Type <b>Coffee Vending Machine</b>	Model <b>9100 IN - 9200</b>	N° T.I. <b>08 - 2022</b>	
Serial Number <b>23920599</b>	Subject <b>New resistance assembly</b>	ISSUED FOR (X)	Action Information <b>X</b>

Be informed that with the aim to improve our equipment, the *boiler assembly* has been modified for the 9100 machine, by introducing:

**Modified Resistance Assembly (1) + new Bulb contrast pin assembly (2)**

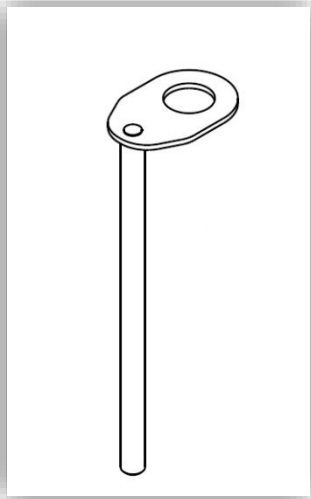
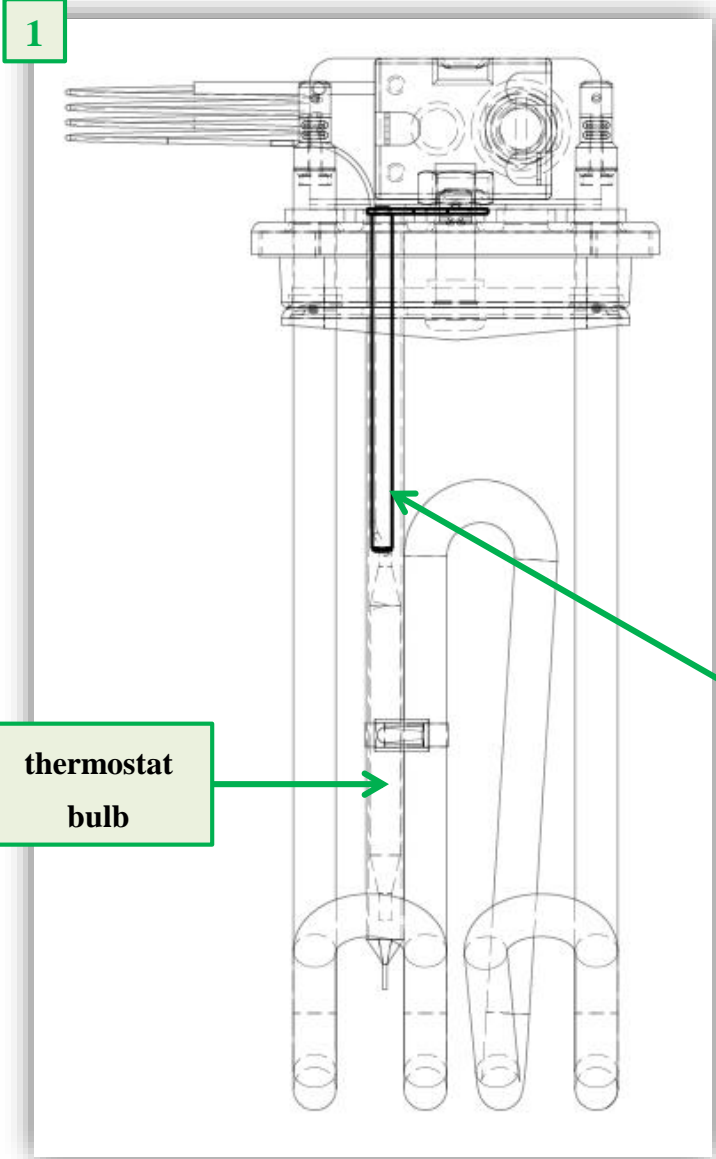
**New Bulb contrast pin assembly**  
Spare code: **264712 SAP:55125608**

The **modified resistance assembly** has the thermostat bulb housed inside a steel tube in contact with the resistance coil

**3** **New Carter**  
Spare code: **264711**  
**SAP: 55125607**

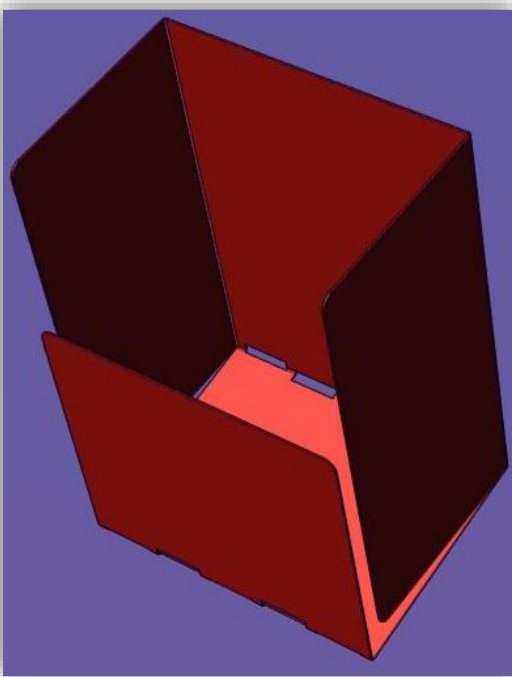
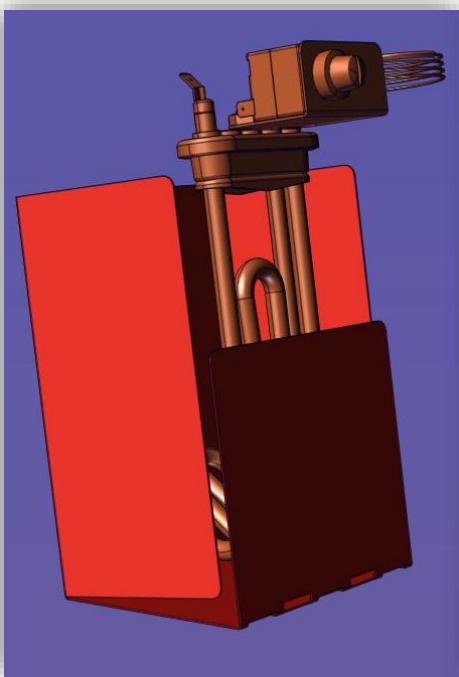
**Pre - modification solution**  
**NO Carter**

The **carter** was introduced to avoid deformation of the plastic body of the boiler in case of dry operation (anomaly of the control system)

The **modified Boiler assembly** (spare code: **260784 sap 55117105**) can be used on **pre-modification** machines. **For machines previous to S/N above** it is possible to use the **modified Resistance assembly** (spare code: **264713**), by ordering the **new Bulb contrast pin assembly** (spare code: **264712**) and the **new Carter** (spare code: **264711**). Or use the old heating element **41611500**
